SUBMITTAL TO THE BOARD OF SUPERVISORS
COUNTY OF RIVERSIDE, STATE OF CALIFORNIA

SUBJECT: FACILITIES MANAGEMENT (FM) AND RIVERSIDE COUNTY FLOOD CONTROL AND WATER CONSERVATION DISTRICT (DISTRICT): Flood Control and Water Conservation District Office Tenant Improvement Project – Approval of Construction Contract with PCN3, Inc., District 1. [$8,389,300 – 100% District Special Accounting Fund 15000 (Previously Approved Project Budget)]

1. Approve Addenda No. 1 through No. 4 to the plans and specifications for the Flood Control and Water Conservation District Office Tenant Improvement Project issued prior to the bid opening date of April 30, 2026;

SHEET NUMBER:
E-5.2

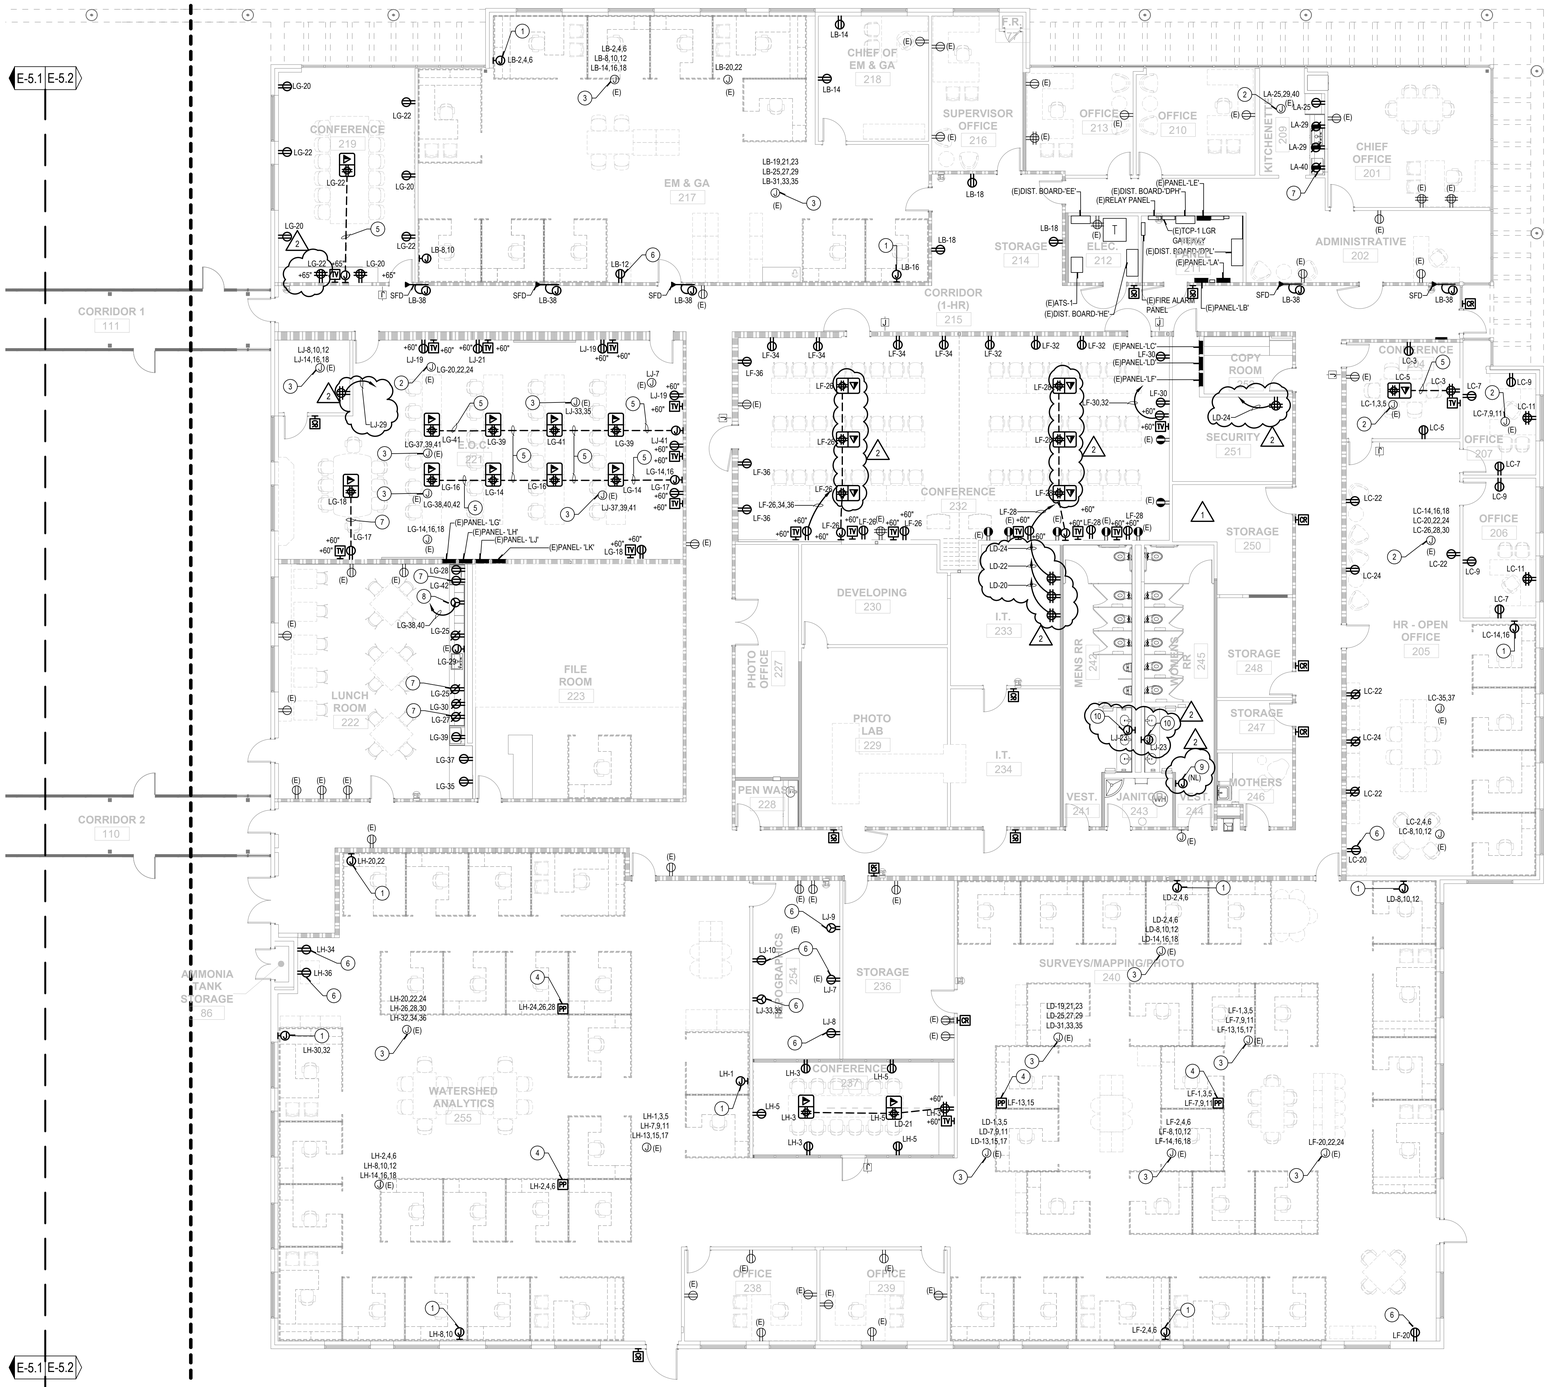
- E-5.2: ELECTRICAL REMODEL PLAN - BUILDING 1
  a. Added power in Conference room 219
  b. Added floor power receptacles in Conference 232
  c. Added power for plumbing fixtures Men & Women RR – 242,245

WC5: IMAGE PRINTED UPSIDE DOWN
LOCATED AT FRONT FACE AND UNDERSIDE FACE OF SOFFIT ABOVE RECEPTION DESK. REFER TO ELEVATION 1A/A5-1.1.

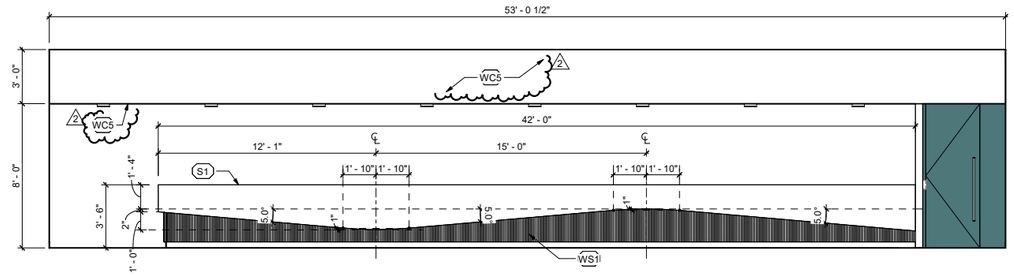
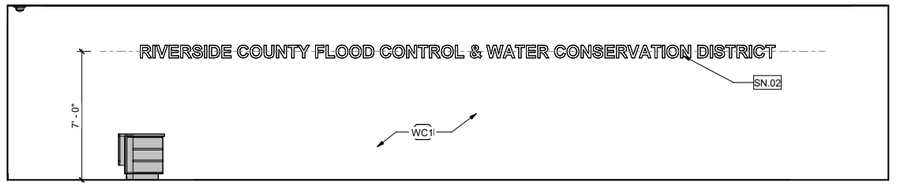
- **RFI 006** – The finish schedule on Sheet A6-1.1 lists WC1, WC2, WC3, and WC4 as a "Digital Image" from MDC Interiors Solutions, however there is no additional information or specification. Please provide a specification for this or advise if this will not be included.
  - **RESPONSE:** WC1, WC2, WC3, and WC4 will be included in the scope. For sizing, lengths are noted on floor plans and heights of wallcovering will be to ceiling height. All are custom digital printed wallcoverings designed by Architect. Refer to attachments SK-01, SK-02, SK-03, and SK-04 provided for reference only; final images will be provided at a later date.

WC1: IMAGE PRINTED RIGHT SIDE UP
LOCATED AT FULL LENGTH OF WALL BEHIND RECEPTION DESK. REFER TO ELEVATION 5A/A5-1.1.

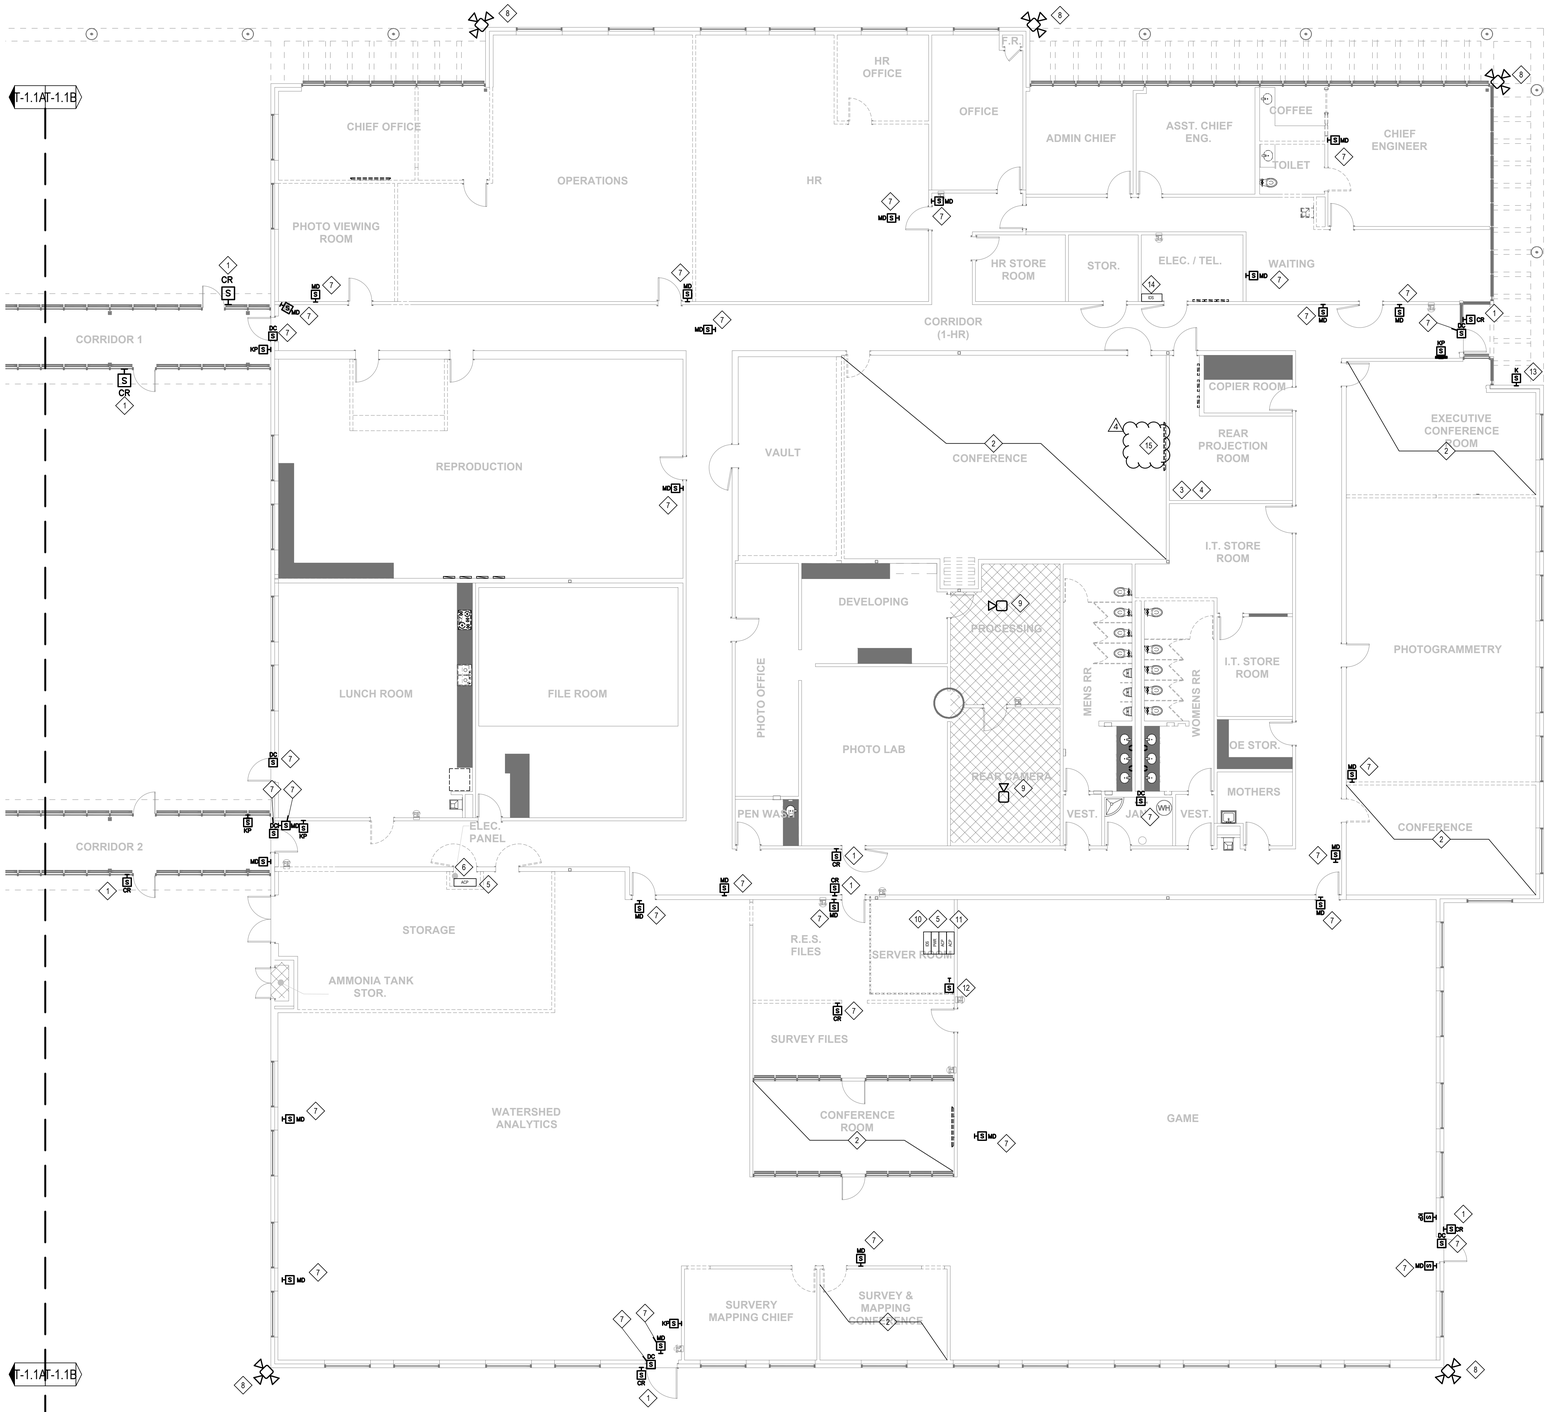
- T-0.1: TECHNOLOGY LEGENDS & NOTES
  a. Revised sheet index.
- T-2.2: TECHNOLOGY DEMOLITION PLAN -BUILDING 1B
  a. Revised notes
- T-4.2: TECHNOLOGY REMODEL PLAN -BUILDING 1A
  a. Revised speaker quantities.
  b. Revised control panel locations.
  c. Added AV to room 103.
  d. Revised room 105 to rough-in only.
- T-4.3: TECHNOLOGY REMODEL PLAN -BUILDING 1B
  a. Revised speaker and camera quantities
  b. Removed cameras and displays.
  c. Clarified display usage in room 251.
  d. Added lectern notes.
- T-5.1: TECHNOLOGY DETAILS
  a. Revised details.
  b. Added lectern detail.
- T-5.2: AV SINGLE LINES
  a. Revised single lines.
- T-5.3: AV SINGLE LINES
  a. Added sheet.
- 27 41 16: AUDIOVISUAL SYSTEMS
  a. Revised specifications
